AGENDA
BEAUFORT COUNTY DESIGN REVIEW BOARD
Thursday, August 4, 2016, 2:30 p.m.
Grace Coastal Church
15 Williams Drive, Okatie, SC 29909
Phone: (843) 255-2140

Beaufort County Animal Shelter

BFG Communications - Conceptual

Parker's Convenience Store – SC HWY 802 & Oyster Factory Road

Conceptual Commercial Plan (Oyster Bluff T-4 HC)

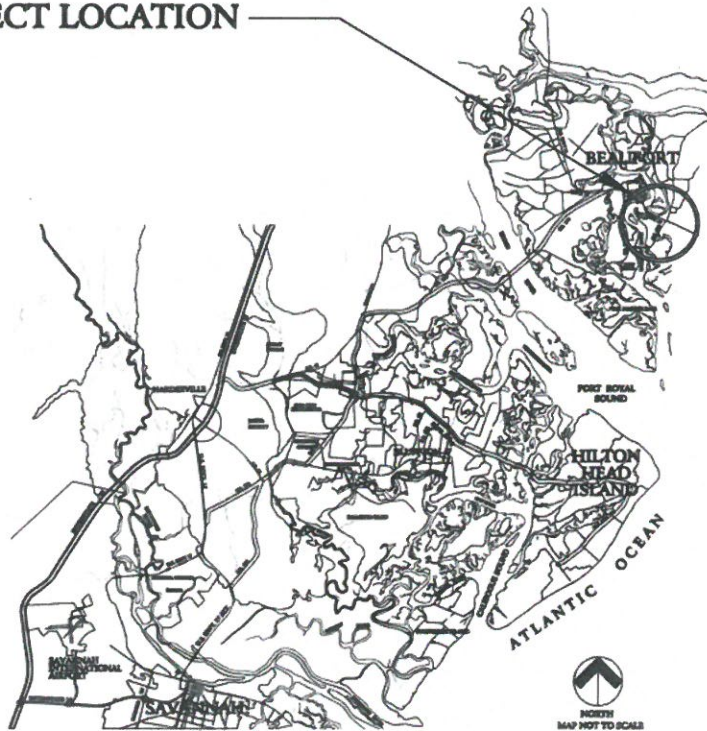
1. The DRB needs to determine whether the building meets the build-to zone requirement both architecturally and functionally. Specifically, the Board will need to determine whether the façade facing Oyster Bluff Drive is the front elevation and that the proposed pavilion acts as an extension of the building to provide frontage along Oyster Factory Road.
